Technical Service Bulletin

NUMBER: 25-001-01

Generic Scan Tool May Not Display Certain DTC's and Erroneous LDP Switch Fault

This bulletin involves selectively erasing and reprogramming the Powertrain Control Module (PCM) with new software (calibration level 01Cal14)

FIGURE 2 - AUTHORIZED MODIFICATION LABEL 80bb0af8

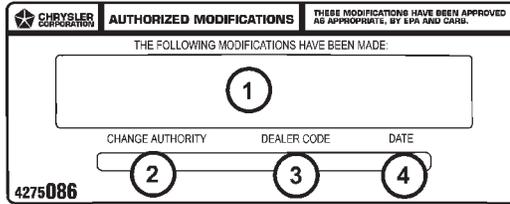
8. Type the necessary information on the “Authorized Modification Label” p/n 04275086 and attach the label near the VECI label (Figure 2).

1-	POWERTRAIN CONTROL MODULE P/N (INSERT P/N) USED
2-	CHANGE AUTHORITY: TSB XX-XX-XX
3-	DEALER CODE: XXXXX
4-	DATE: XX-XX-XX
